## Product Change Notification / ALAN-28BFQE464

CCB 5102 Initial Notice: Qualification of CARC as new assembly site for LX7167ACLD-TR and LX7167CLD-TR catalog part numbers (CPN) available in 8L WDFN (2x2x0.8mm) package.

# CCB 5102

### PCN# ALAN-28BFQE464

## Pre and Post Change Summary

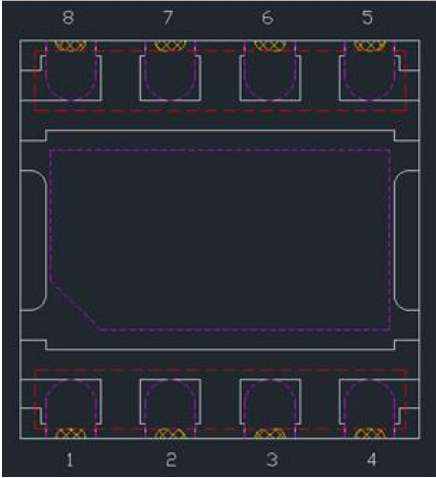
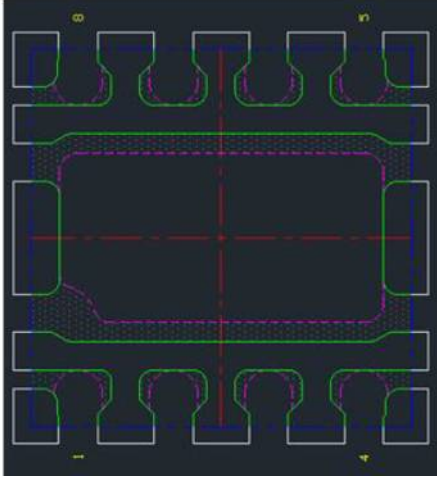
ASAC (UDG)	CARC

<table><tr><td>Material</td><td>C194 FH</td></tr><tr><td>Paddle Size</td><td>43 x 69 mil</td></tr><tr><td>DAP Surface Prep</td><td>Ag</td></tr><tr><td>Lead-lock</td><td>No</td></tr></table>	Material	C194 FH	Paddle Size	43 x 69 mil	DAP Surface Prep	Ag	Lead-lock	No	<table><tr><td>Material</td><td>C194</td></tr><tr><td>Paddle Size</td><td>43 x 67 mil</td></tr><tr><td>DAP Surface Prep</td><td>Spot Ag</td></tr><tr><td>Lead-lock</td><td>Half-etched</td></tr></table>	Material	C194	Paddle Size	43 x 67 mil	DAP Surface Prep	Spot Ag	Lead-lock	Half-etched
Material	C194 FH																
Paddle Size	43 x 69 mil																
DAP Surface Prep	Ag																
Lead-lock	No																
Material	C194																
Paddle Size	43 x 67 mil																
DAP Surface Prep	Spot Ag																
Lead-lock	Half-etched
